APPENDIX-B
CORRESPONDENCE

Re: Route 8 - Interchanges 22-30
Deficiencies/Needs Study

Subject: Route 8 Interchanges 22-30 Deficiencies/Needs Study
Response to Comments on Draft Final Report

RE: Route 8 Interchanges 22-30 Deficiencies/Needs Study
State Project 124-164

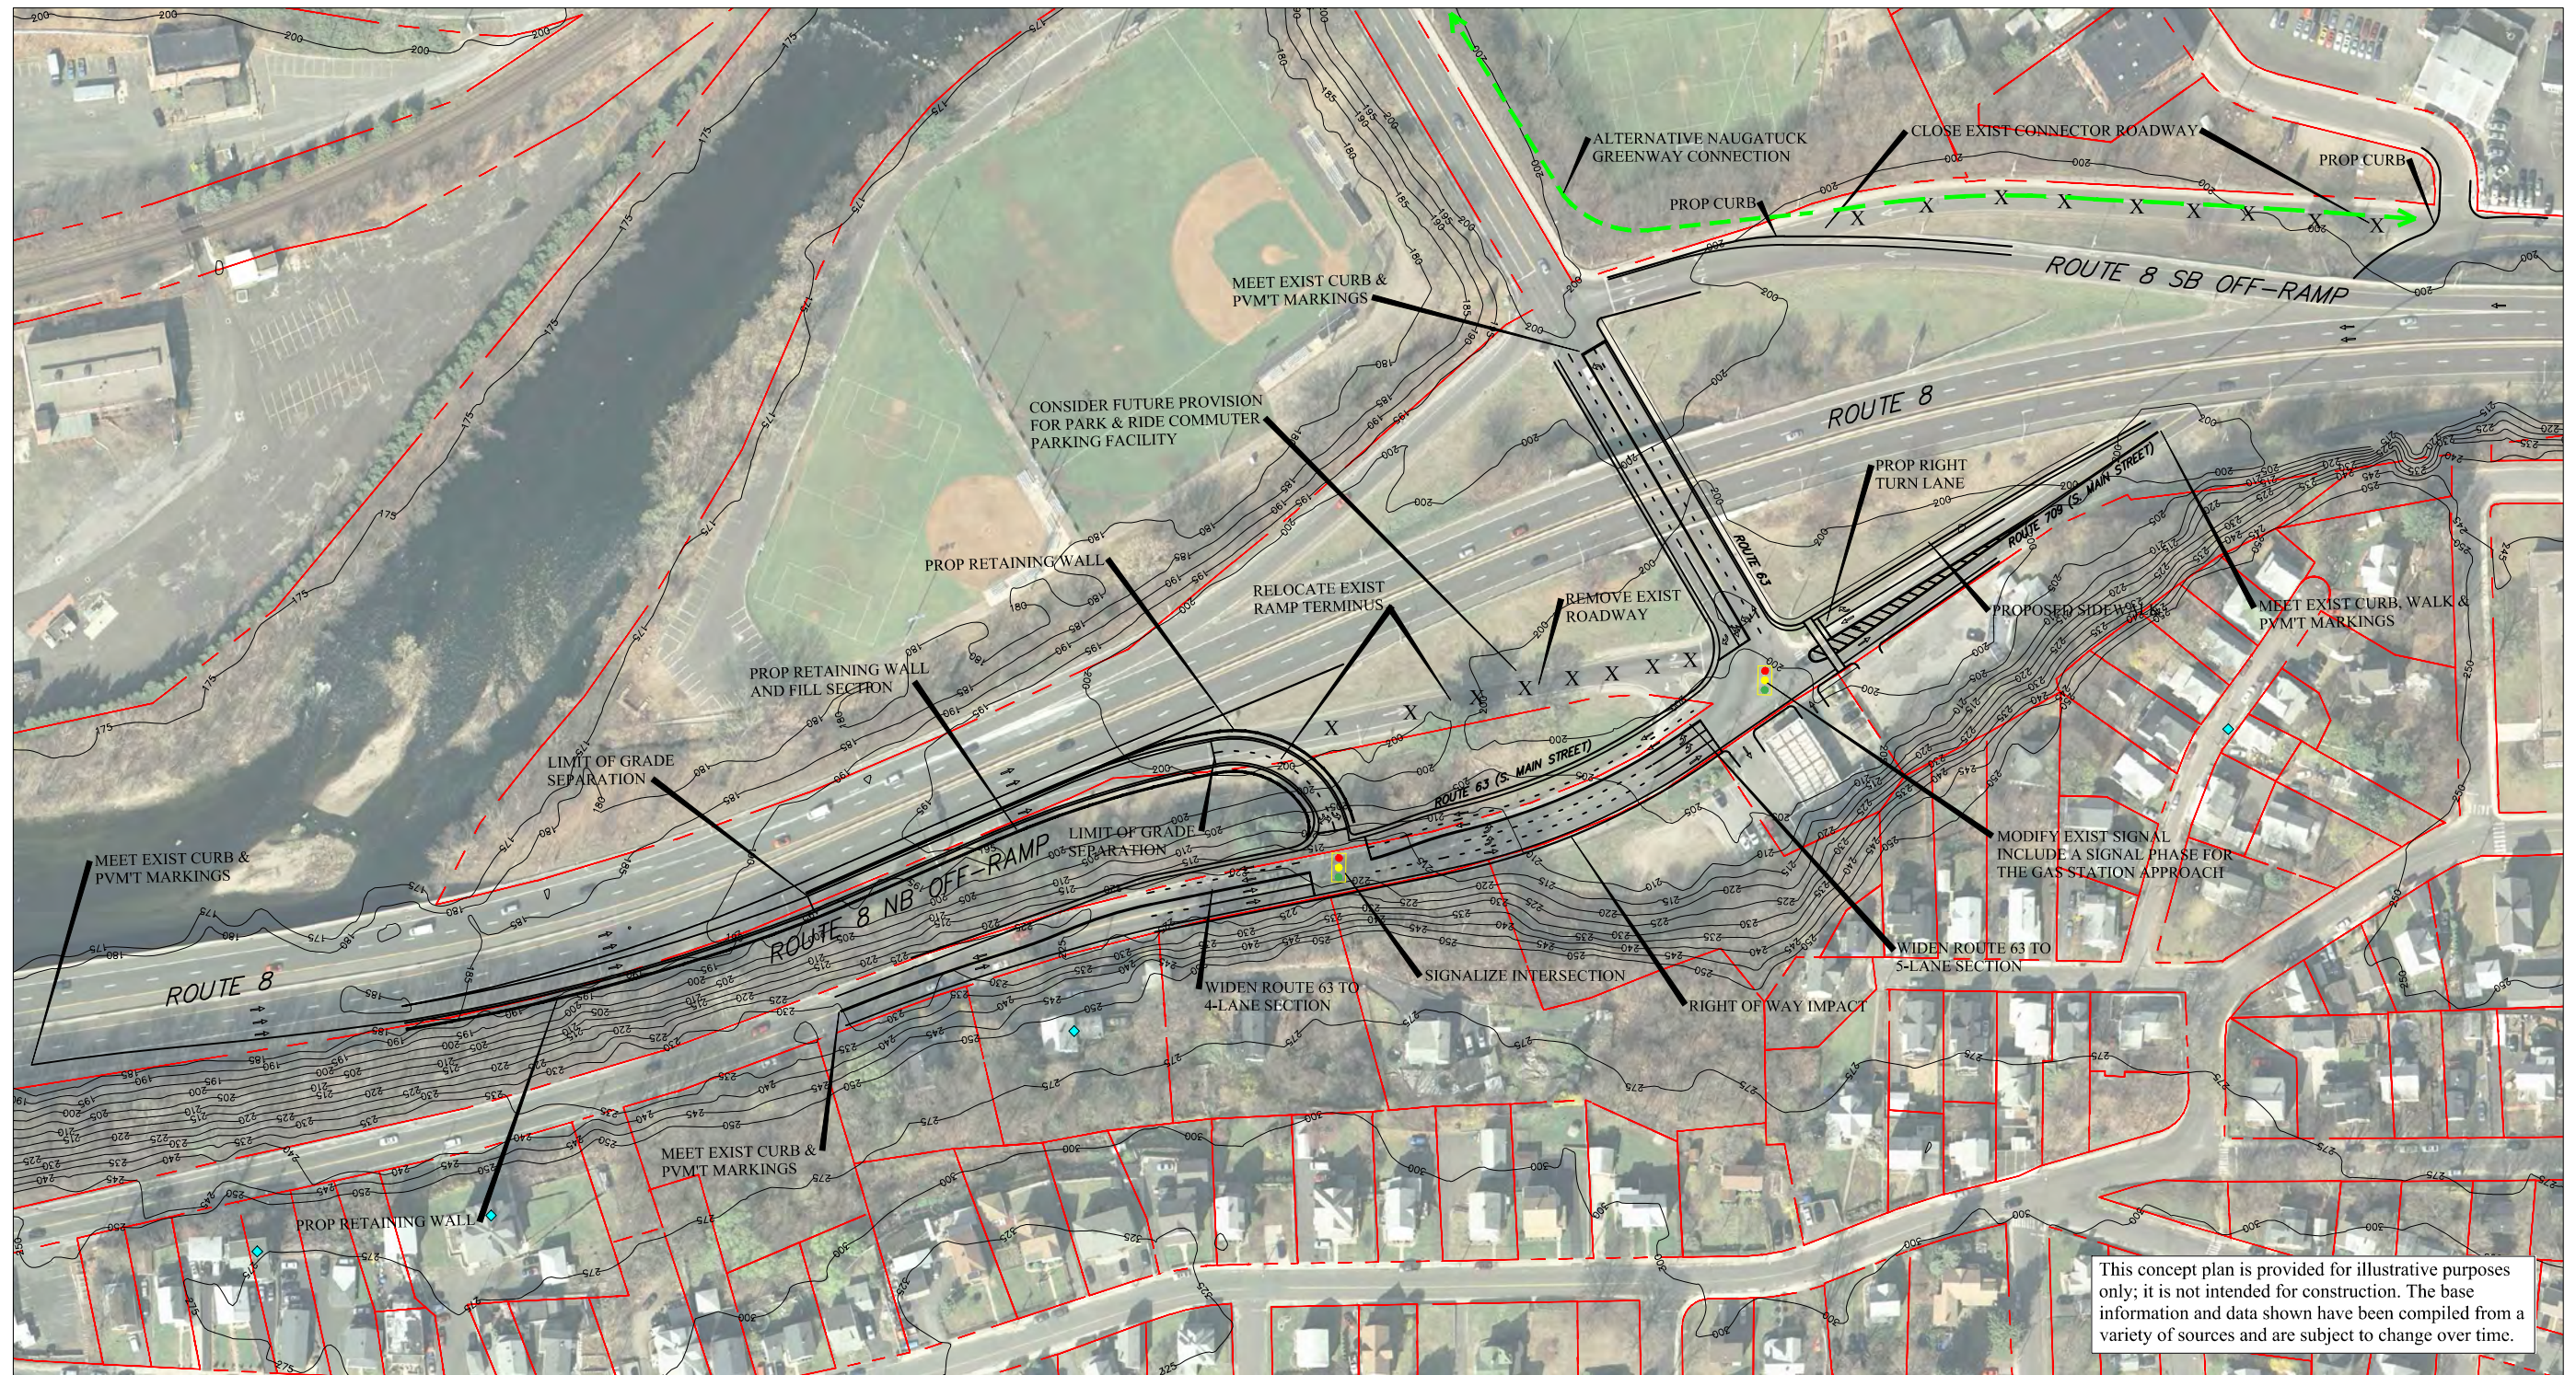
Interchange 26: Intersection of CT-63 and Route 8 SB on-ramp: The left turn lane on NB CT-63 at this location is existing and will remain. The only recommendation for this location is the closure of the existing connector roadway. The pavement marking arrows on CT-63 are revised to include a through lane and a left turn lane. (Please see attached revised drawing for this location).
